UTILITY ADJUSTMENT PLANS - ALAFAYA TRAIL

SHEET NO. 165

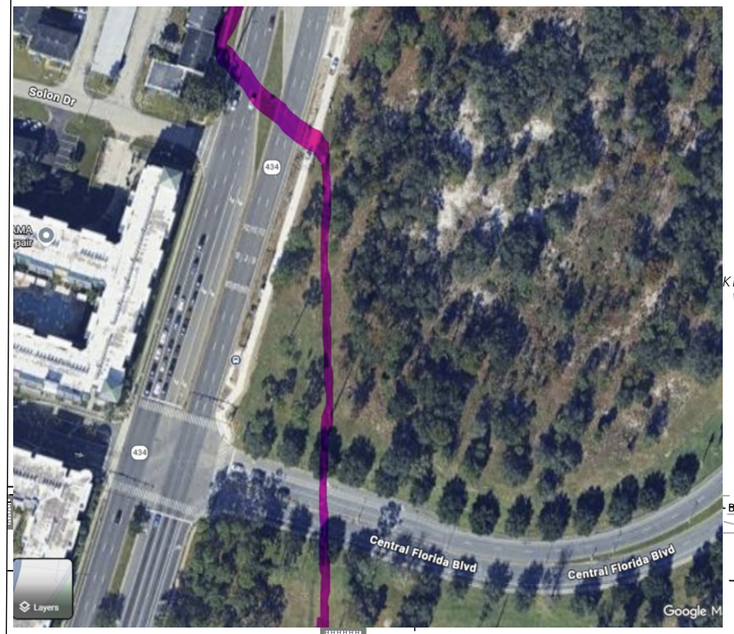
+93.26 99.91 RT.
ADDITIONAL EXIST. EASEMENT R/W (PER OR 6638, PG 3748)
POLE# D09E
PROPOSED WOOD POLE AT BACK OF SIDEWALK
ATB2 280W TYPE III LED ON 8' BRACKET AT 30' MH
(BY DUKE)
EXIST. PULL BOX TO BE RELOCATED (BY MCI)
EXIST. PULL BOX TO BE ADJUSTED (BY LEVEL 3)
EXIST. PULL BOX TO BE ADJUSTED (BY OTHERS)
EXIST. FOC TO REMAIN
+54.84
POLE# D09E
PROPOSED WOOD POLE AT BACK OF SIDEWALK
ATB2 280W TYPE III LED ON 8' BRACKET AT 30' MH
(BY DUKE)
POLE# D08W
LUMINAIRE
TYPE III LED
(BY DUKE)
existing high voltage power line - very expensive and time consuming to move... see pictures above. Creates a triangle "wedge" that probably cannot be built on

SHEET NO. 166

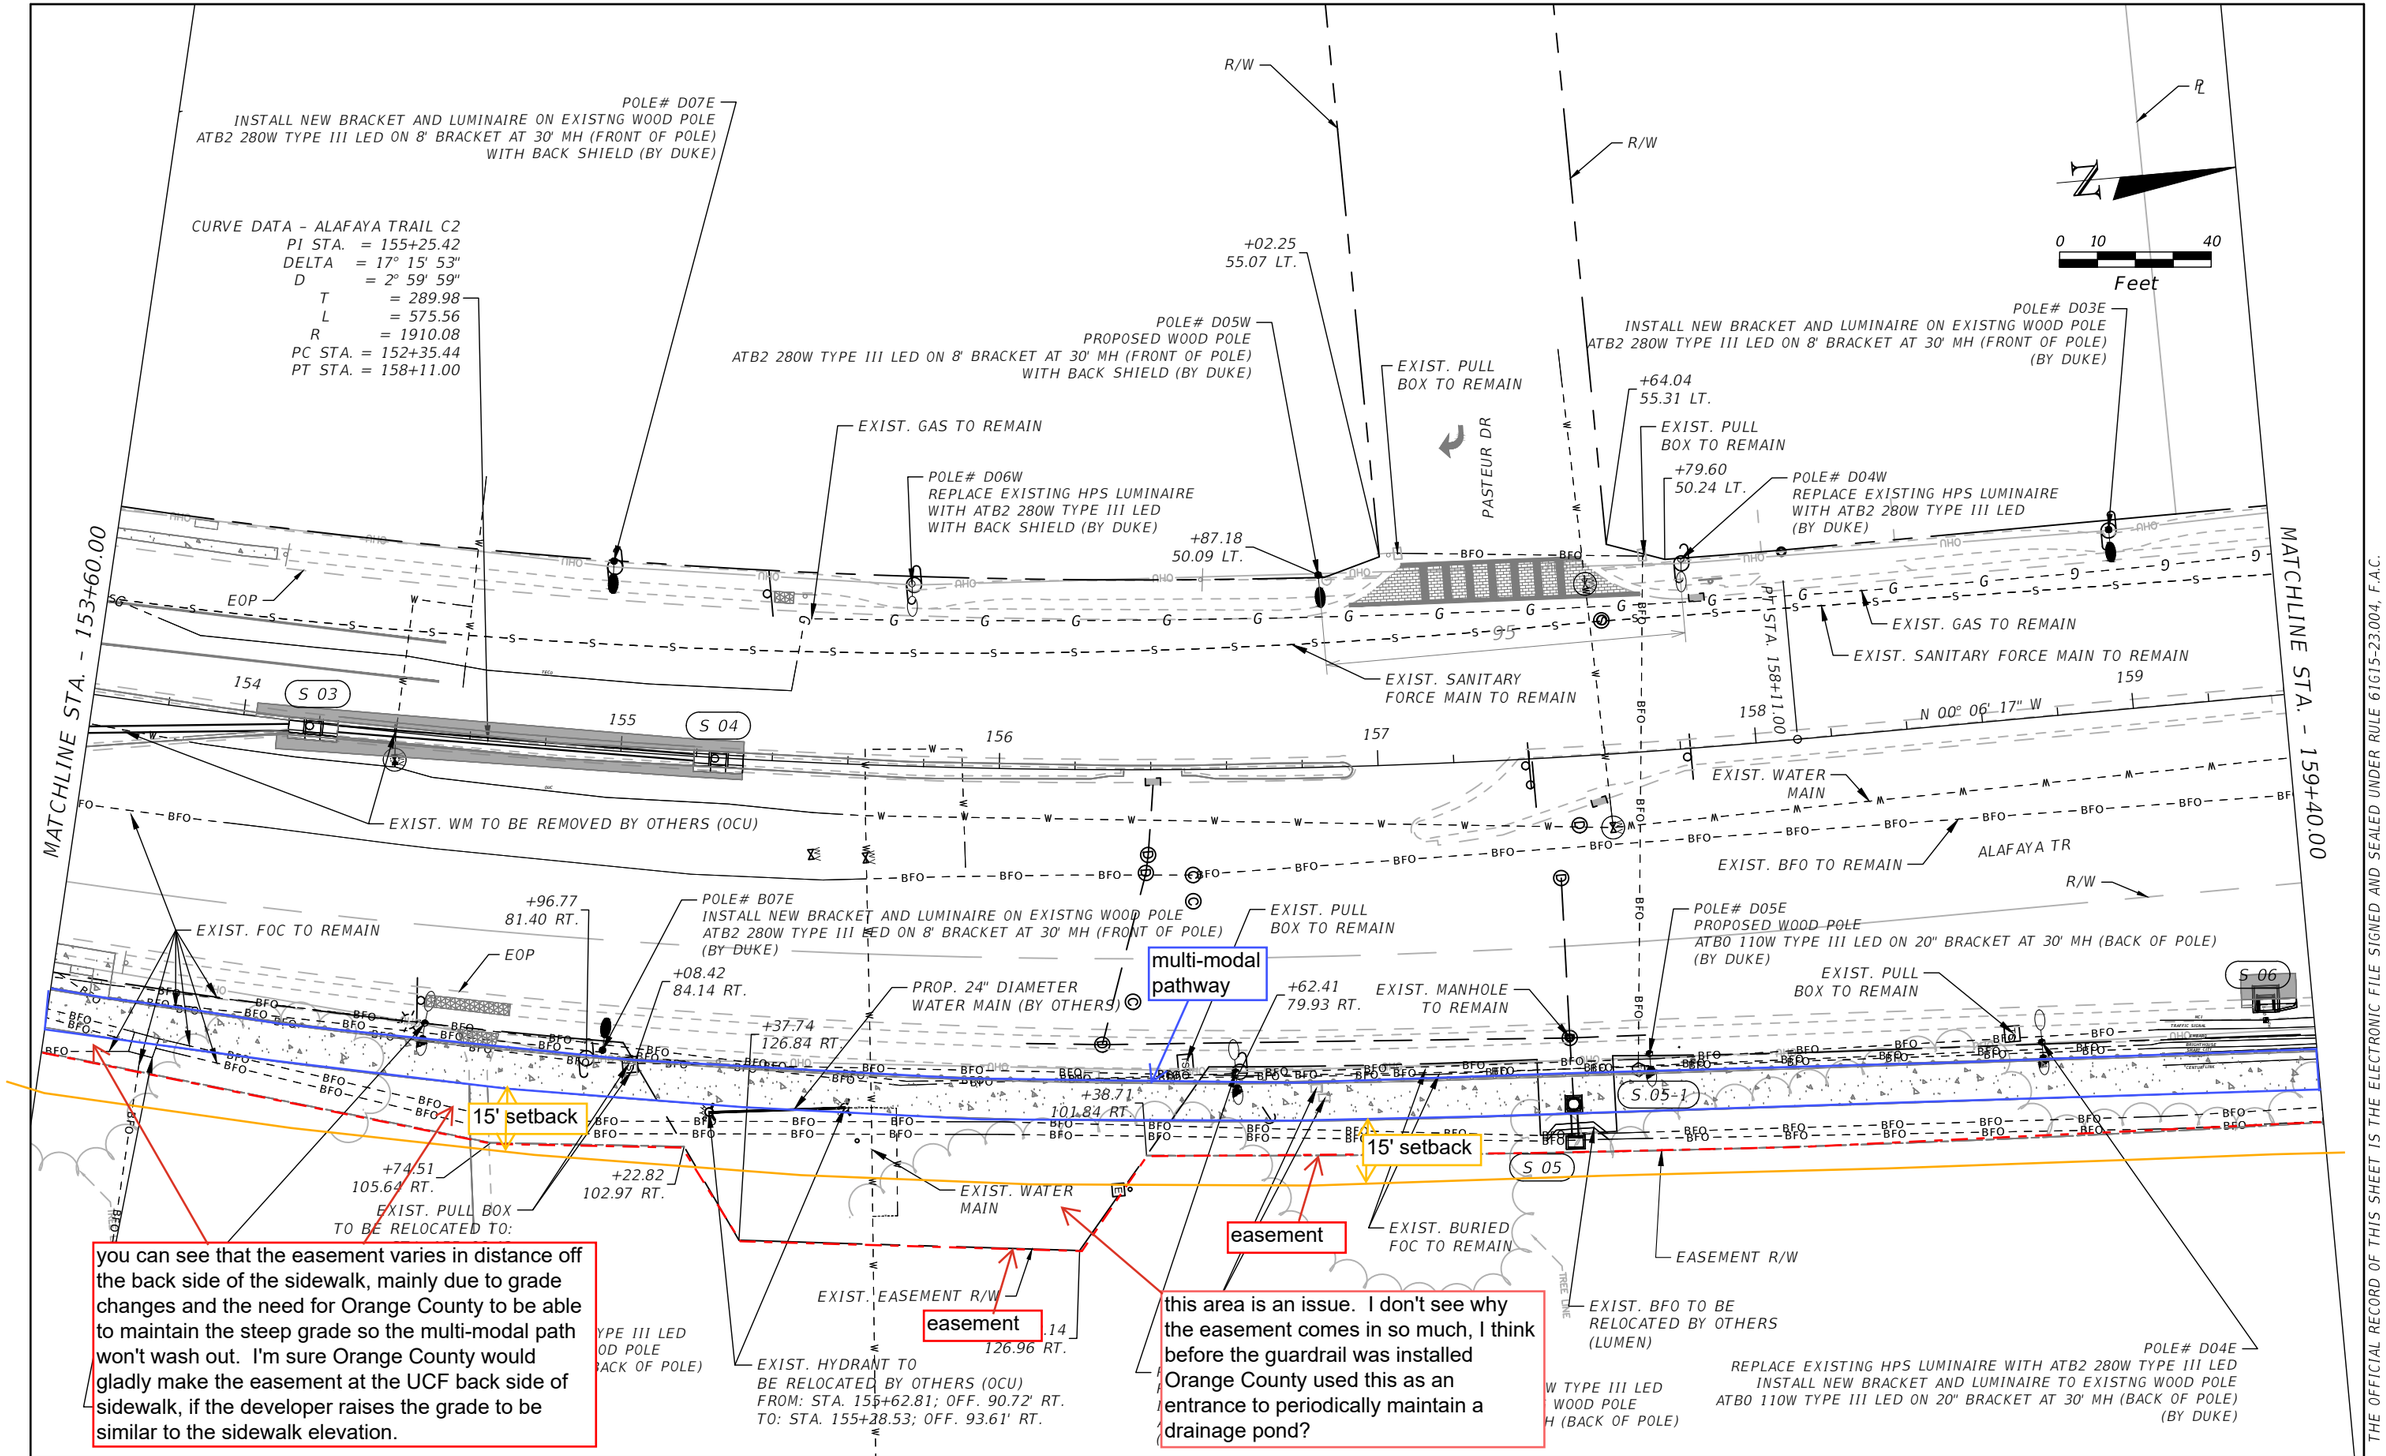
you can see that the easement varies in distance off the back side of the sidewalk, mainly due to grade changes and the need for Orange County to be able to maintain the steep grade so the multi-modal path won't wash out. I'm sure Orange County would gladly make the easement at the UCF back side of sidewalk, if the developer raises the grade to be similar to the sidewalk elevation.

this area is an issue. I don't see why the easement comes in so much, I think before the guardrail was installed Orange County used this as an entrance to periodically maintain a drainage pond?

SHEET NO. 176

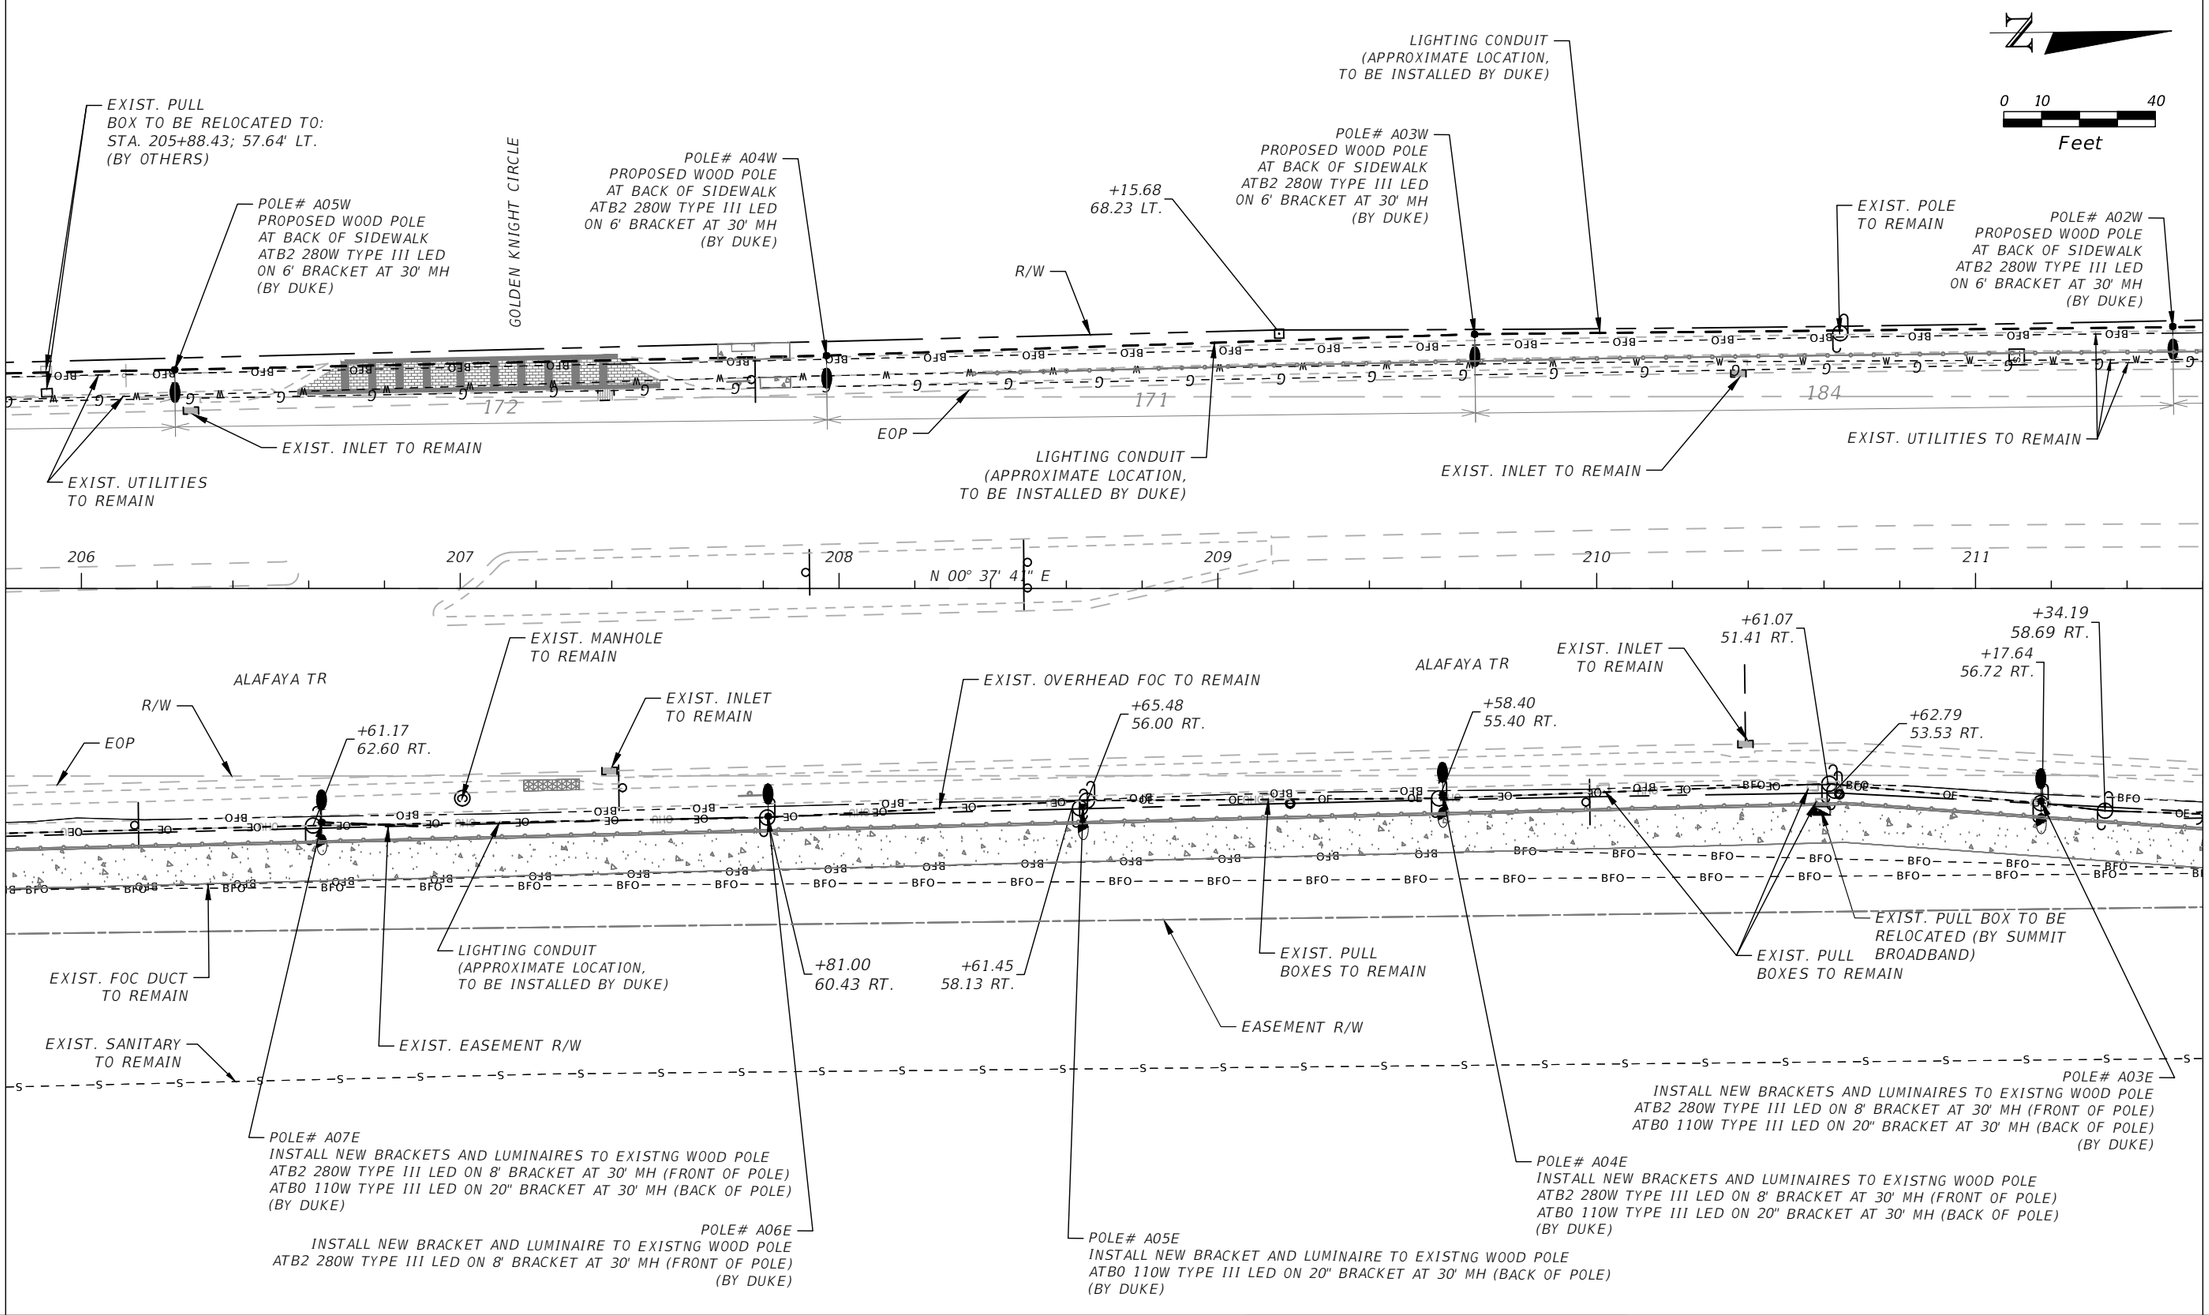
these high-voltage power lines are all along McCulloch and their easement will drive where the developer can build...

steep slope, probably a 10' drop along much of McCulloch. there are also reclaimed water boxes about 20' from the back edge of the sidewalk, all along this road - these may also drive where the developer can build.
